Altronic Service Bulletin #519

ISSUED: 6/8/18

Flex Panel PCB

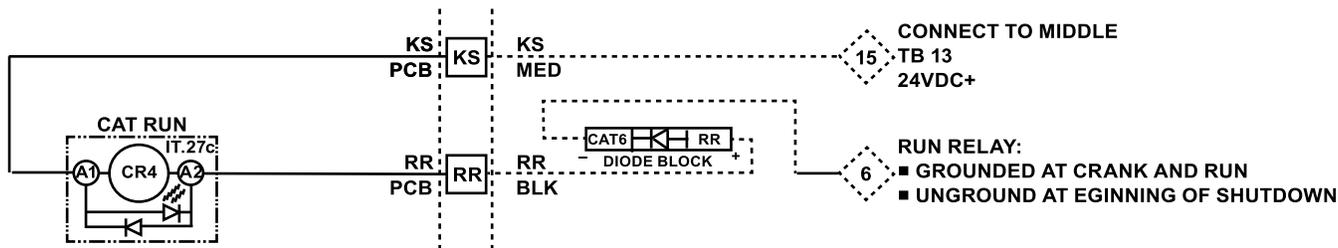
Refer to the picture below. The board will have a board part number on it 602885 followed by a revision number. Any board with a revision number "0" or "1" is affected.

An issue has been identified where incorrect operation of the panel light on the Caterpillar 3300B MIDS panel has been identified. This incorrect operation does not damage any components, nor does it affect the normal day-to-day operation of the systems. This occurs when a powered MIDS panel is connected to an unpowered Flex Panel PCB via the KS and RR terminals. In this condition the signal at the RR terminal causes the green "Run light" on the MIDS panel to incorrectly illuminate.

1. For all current panels in the field exhibiting the described condition Altronic will provide, upon request, a diode terminal block. This terminal block can easily be installed by snapping it onto the DIN rail in the panel and connecting the two wires.

Connect the "RR" terminal from the PCB to the top side of the diode terminal block using the wire marked "RR".

Connect the bottom terminal of the diode terminal block to the CAT engine MIDS panel at terminal 6 with a new wire (16 gauge is recommended).

2. All new Flex Panels with Rev0 or Rev1 PCBs will be shipped with an external diode terminal block. The diode block can be placed into service by either the packager or the end-user when interfacing with a CAT 3300B engine MIDS panel by following the above directions.

3. An improvement to the PCB is under development that will add built-in diodes so that the external diode terminal block will no longer be needed.
